July 31, 2018

Ref: 12815.00

Re: DEP File No. SE 049-0805
Revised Notice of Intent: South Coast Rail – New Bedford Main Line NOI
New Bedford, Massachusetts
Responses to Nitsch Engineering, Inc. Comments of July 16, 2018

NEW BEDFORD MAIN LINE TRACK PLAN AND PROFILE STA. 2666+60 TO STA. 2677+60

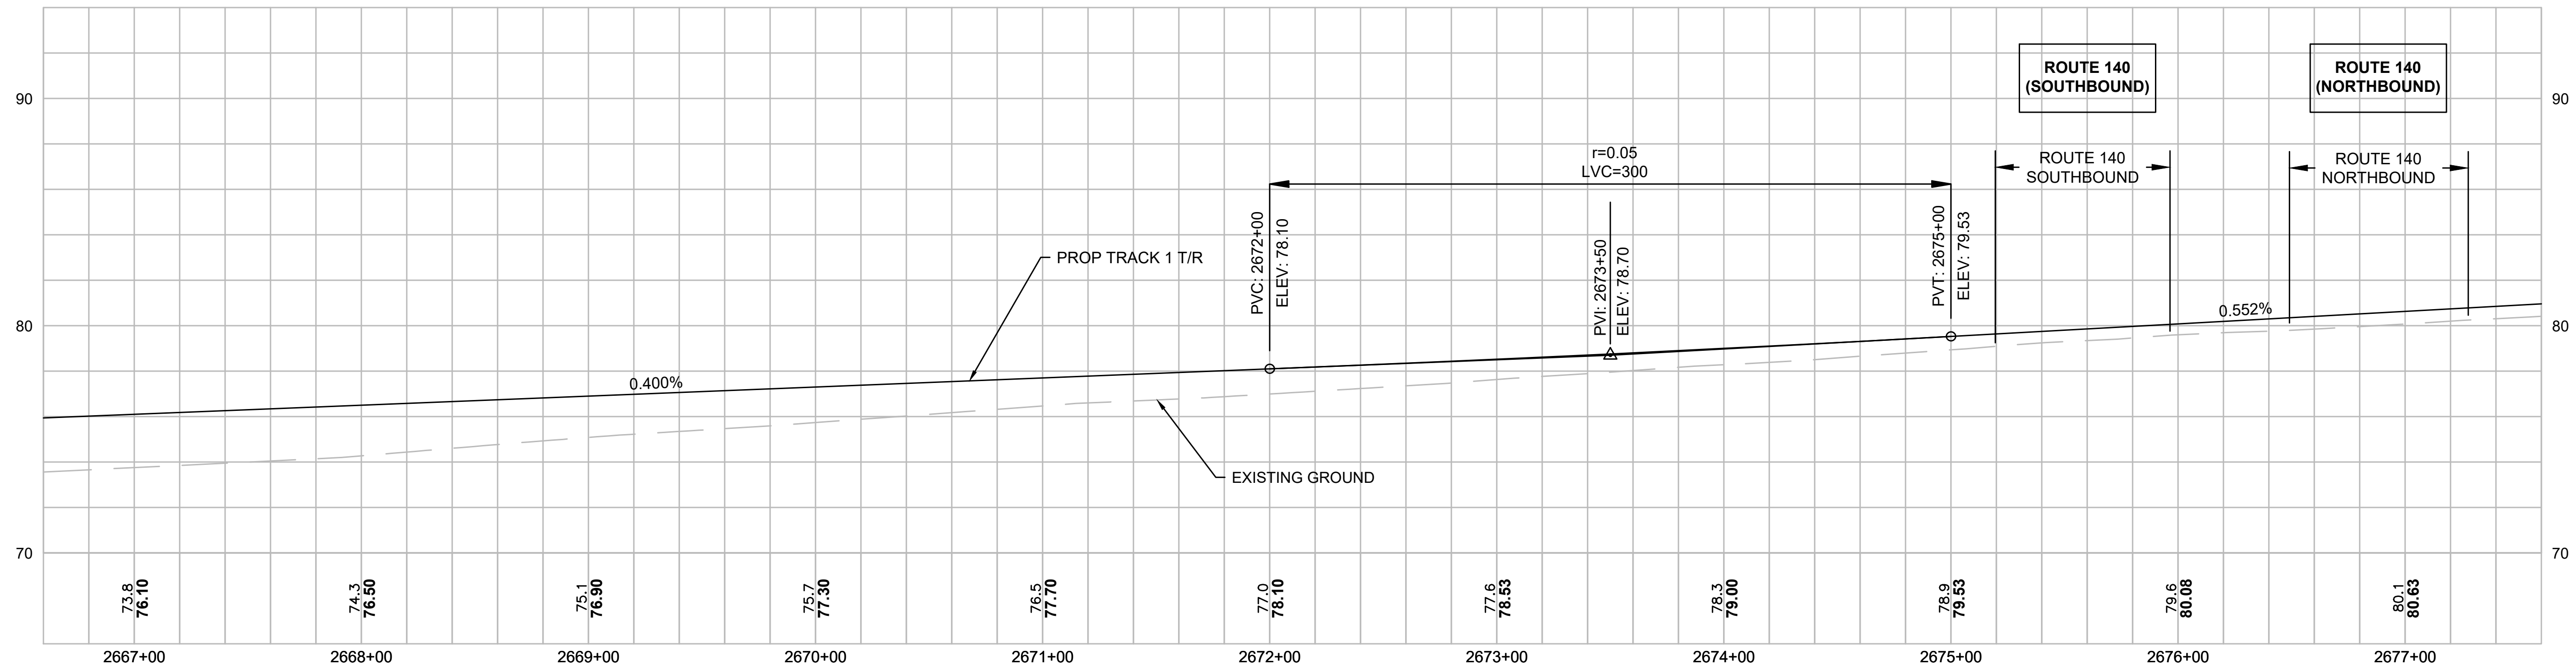
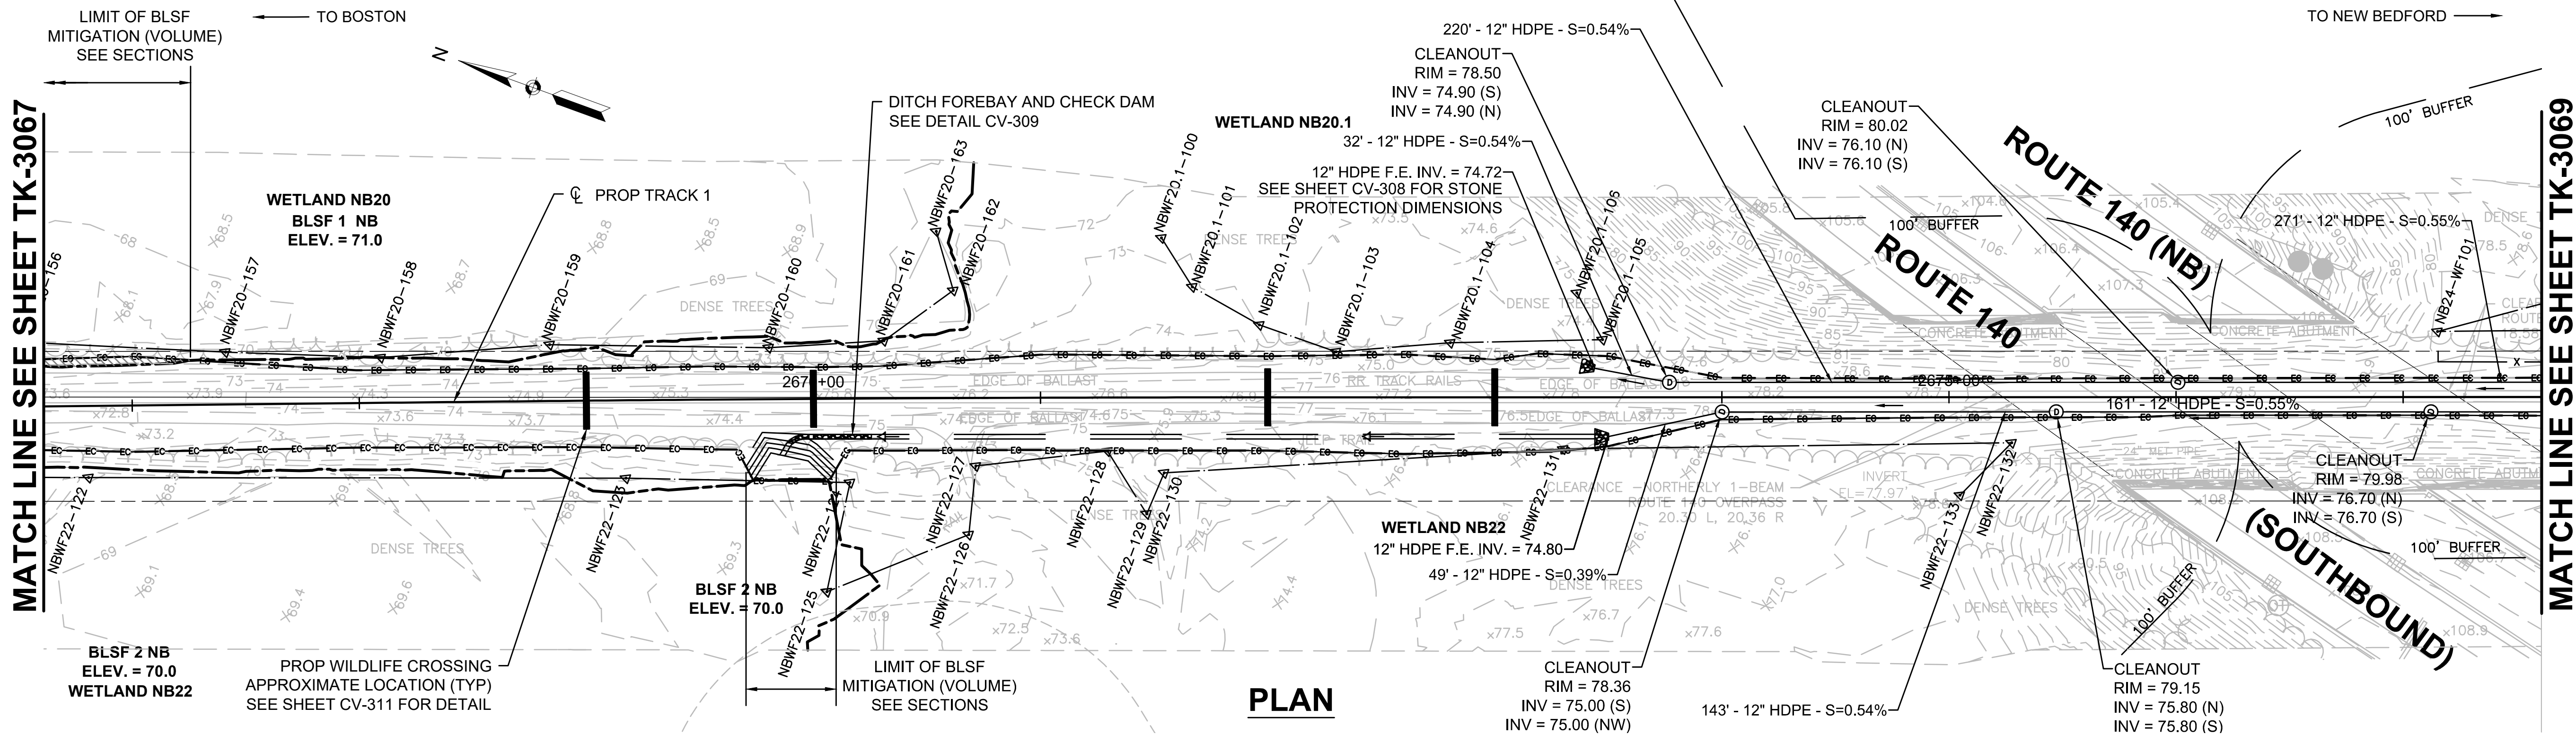
Comment #1(b): *Fill of Bordering Land Subject to Flooding is shown graphically but not graded. The Applicant has responded that grading is not typically shown on railway plans and that the contractor builds from the profile. The rail cross sections do show drainage swales adjacent to proposed tracks. However, the sediment forebays described in the stormwater report do not appear in the plans or cross sections. Given the information provided, with cross sections every 100 feet, it is difficult to quantify or verify the amount of floodplain fill.*

Response #1(b): The plans have been revised to clearly show the location of swale forebays and check dams with cross references to the appropriate detail (found on Sheet CV-309). Cross referencing for the under drain outlet protection detail found on Sheet CV-308 has also been provided. The majority of the compensatory storage mitigation is accomplished with 'shoulder shaving' which involves fine grading just outside the limit of the track section. This fine grading is typically less than 1-foot and can only be shown in the cross sections because grading on the plan views would not show up clearly with 1-foot contouring. The limits of BLSF mitigation are identified on the plans with reference to the applicable cross sections. The mitigation area that requires construction in addition to shoulder shaving (in the vicinity of Station 2670+00 RT) has been graded in plan view and can be found on Sheet TK-3068.

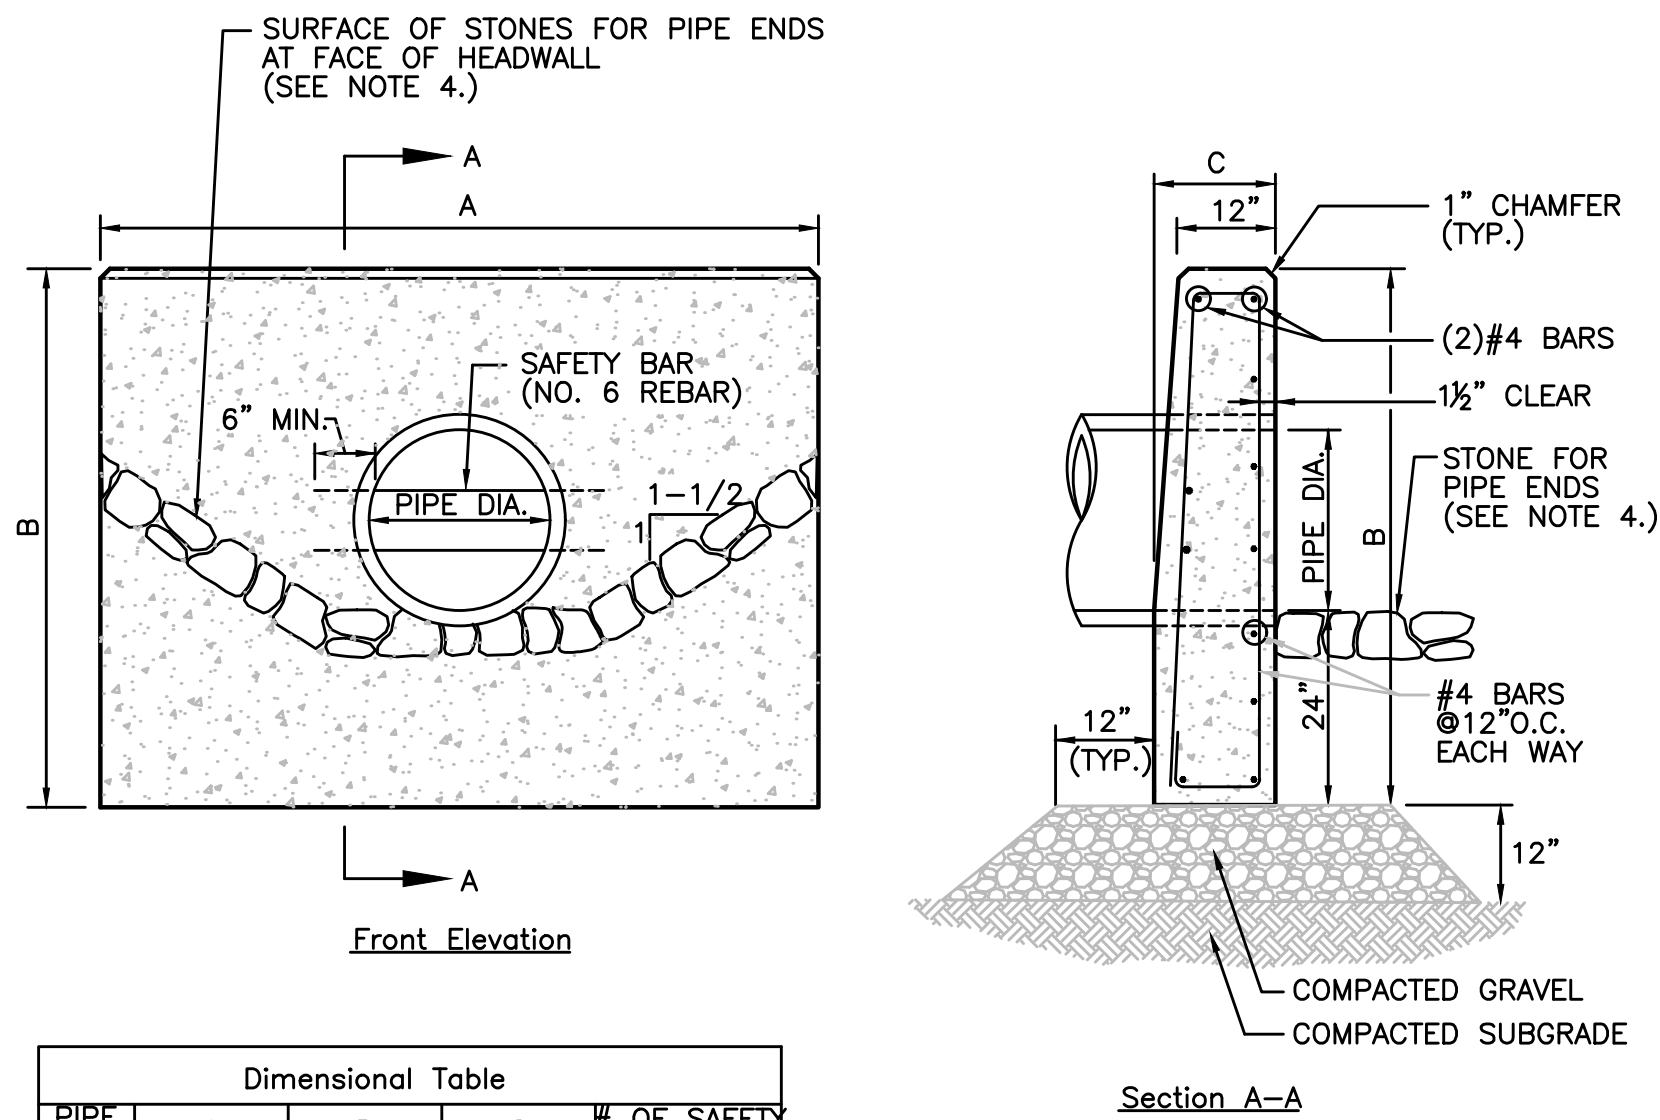
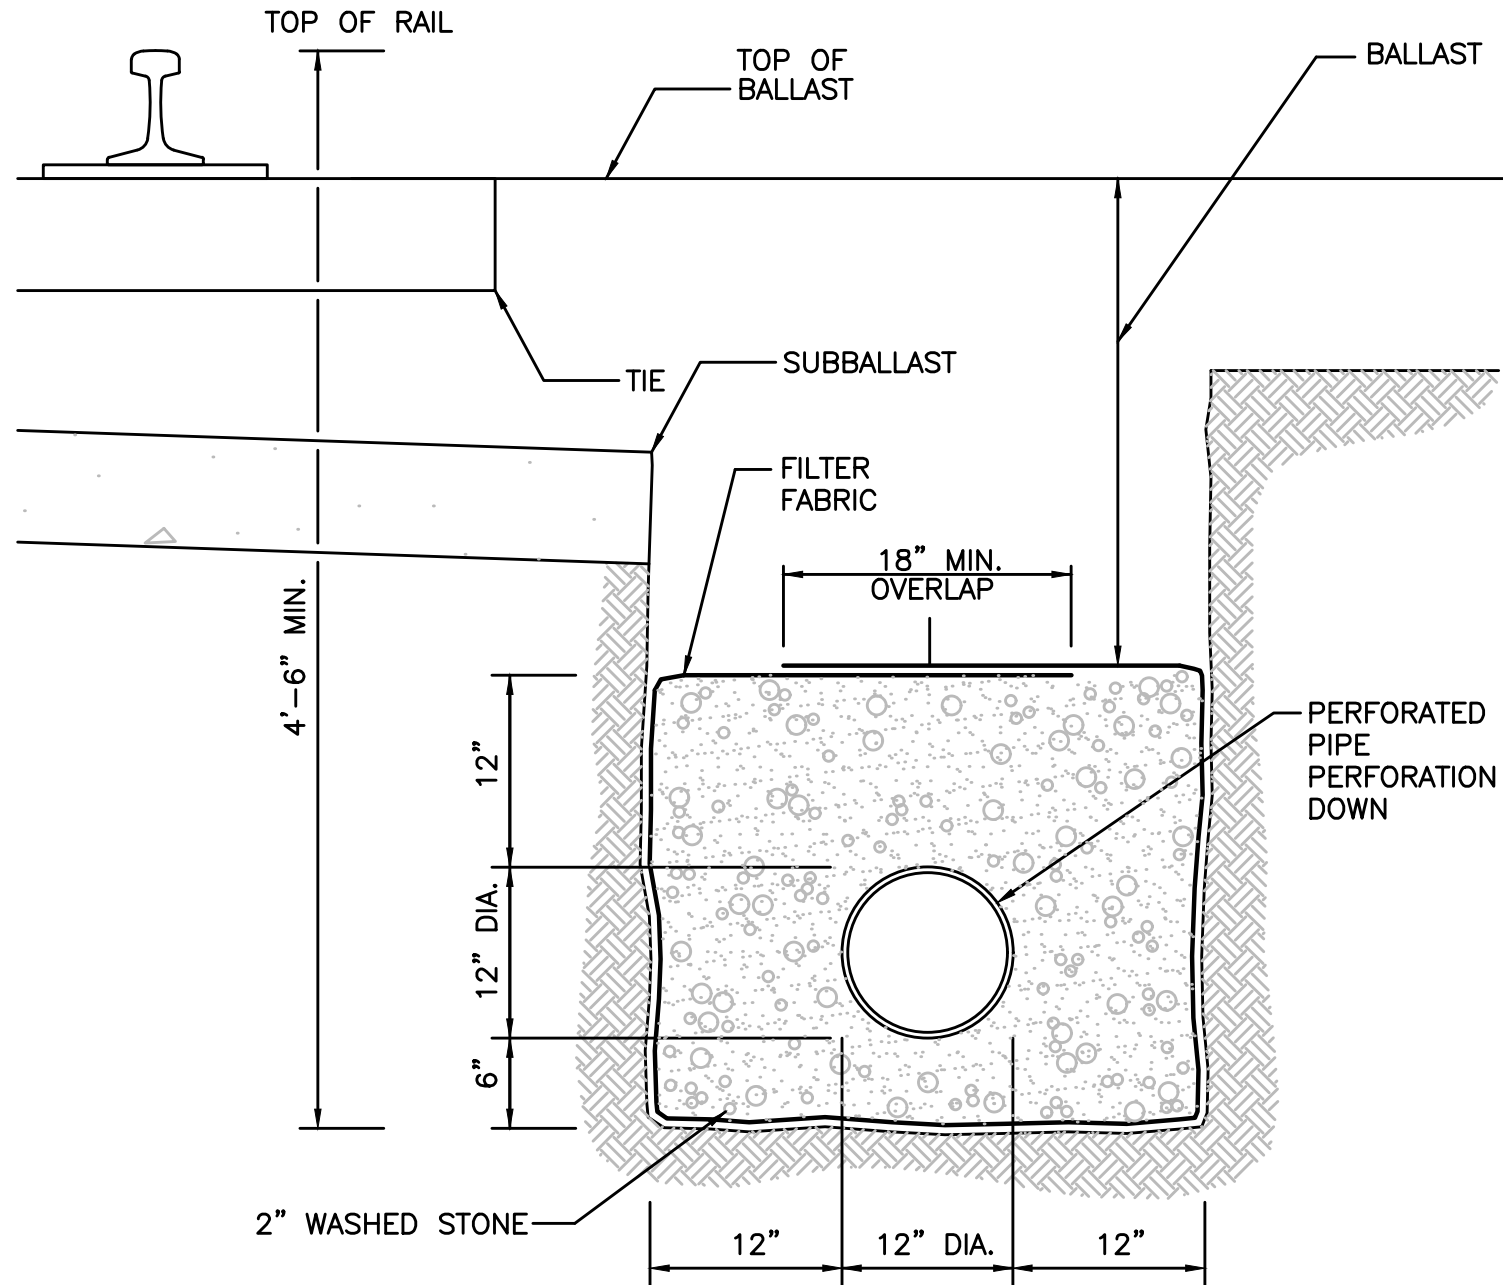
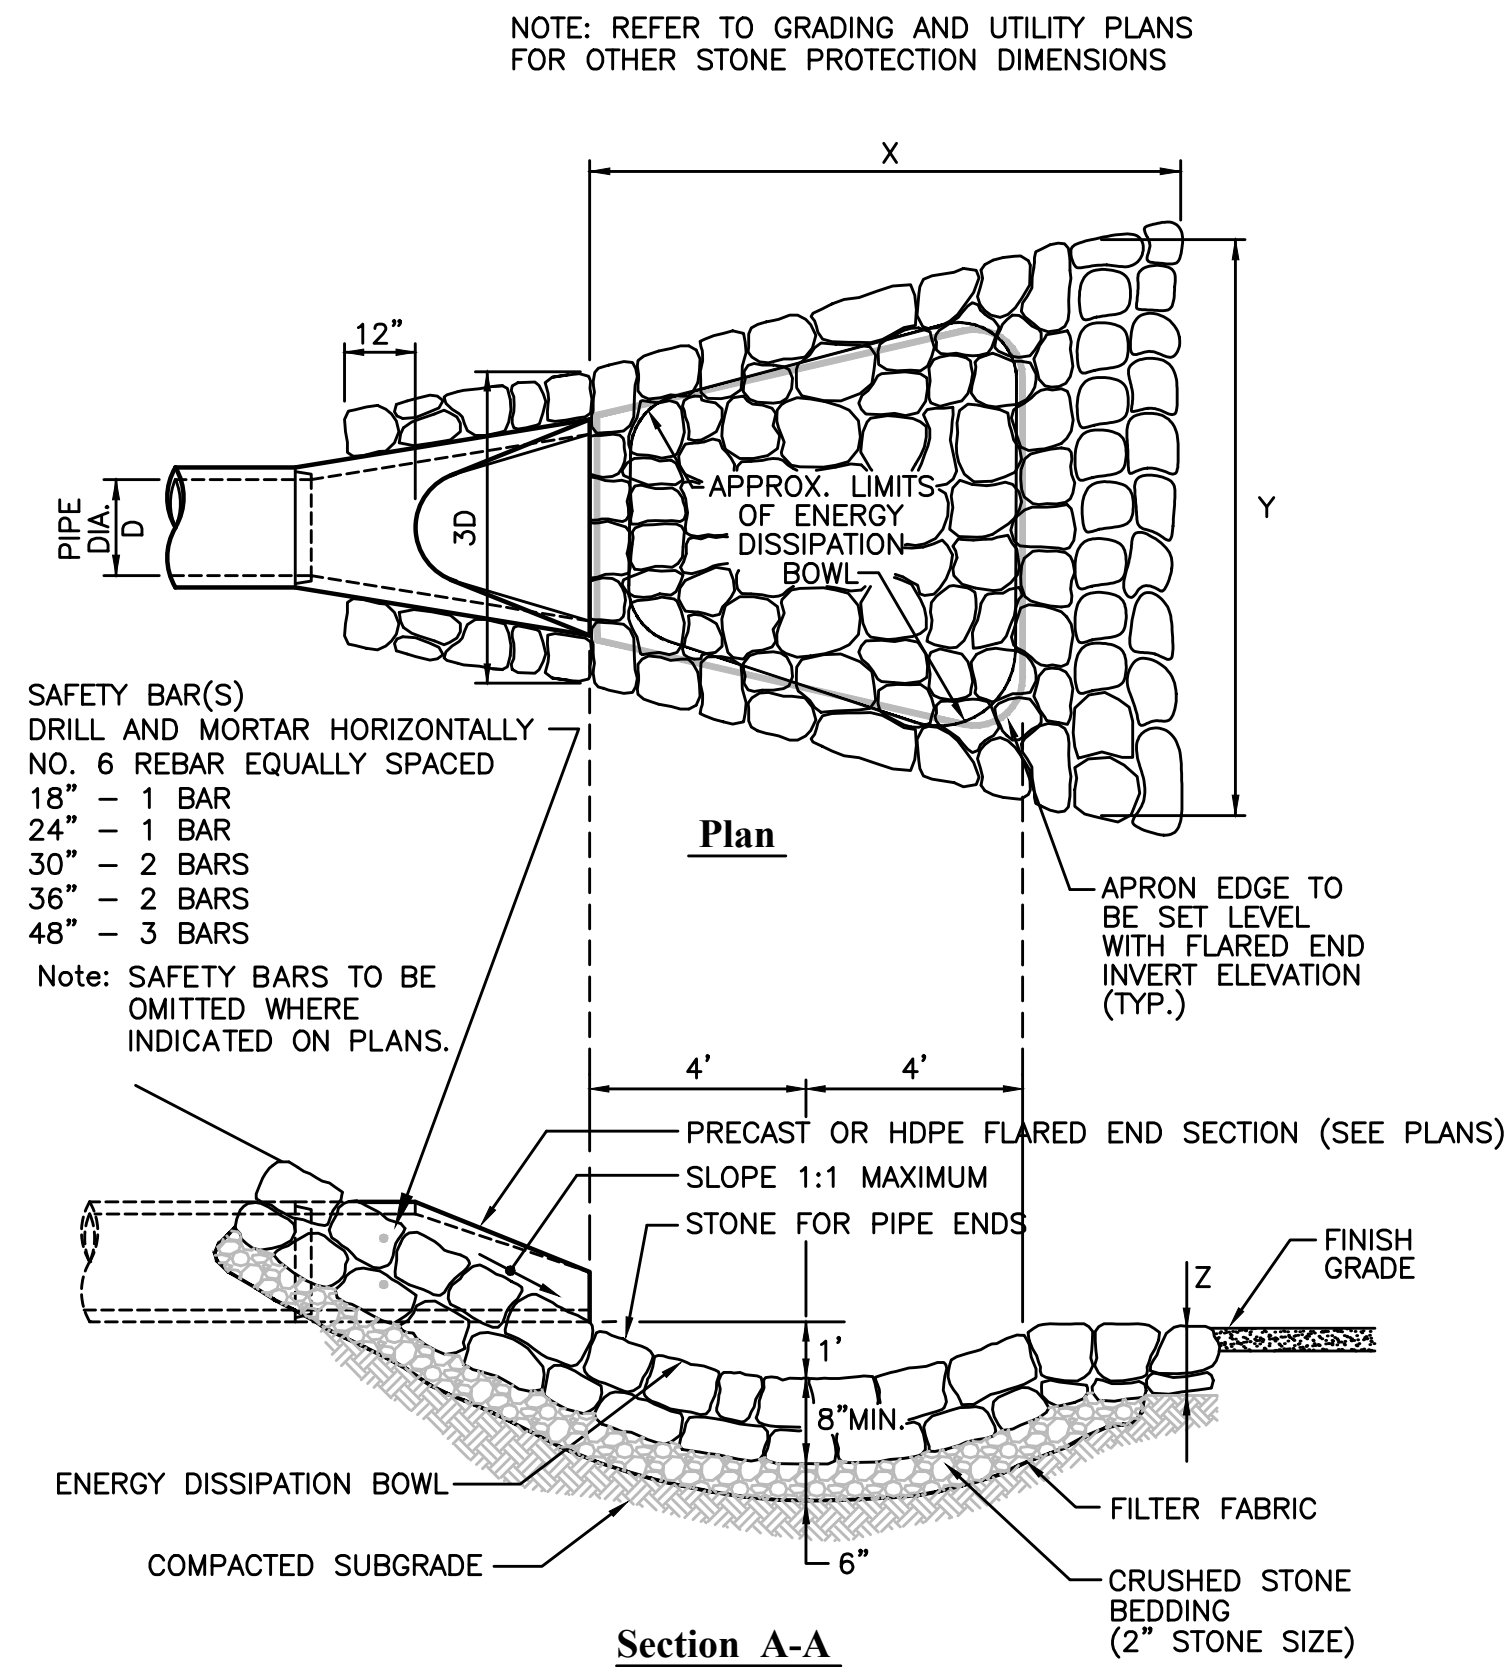
Comment #9. *The Stormwater Report includes a table showing dimensions for rip-rap pads at the underdrain discharge points. The dimensions shown in this table should be reflected in the plans, either with labels at each location or a table on the detail sheet. The pads should be drawn to scale on the plans. The riprap pads prevent scour and erosion at the discharge points. However, they do not provide TSS removal. The Applicant has indicated that the Flared End Section detail has been revised and submitted but the sheet (CV-308) containing this detail was not resubmitted.*

Comment #11: *The Applicant has indicated that the Oil/Water Separator shown on sheet CV-308 has been removed and sheet CV-308 has been resubmitted. This sheet was not resubmitted with the last submittal.*

Response #9: The updated Sheet CV-308 is included with this letter and provides the tabular referencing for each location as suggested. Cross referencing on the plans back to this detail is also included at each outlet location. Also, as previously noted, the same cross referencing and tabulation is provided for the vegetated swale forebay and check dam detail.

Response #11: The Oil Water Separator has been removed from Sheet CV-308 (attached).
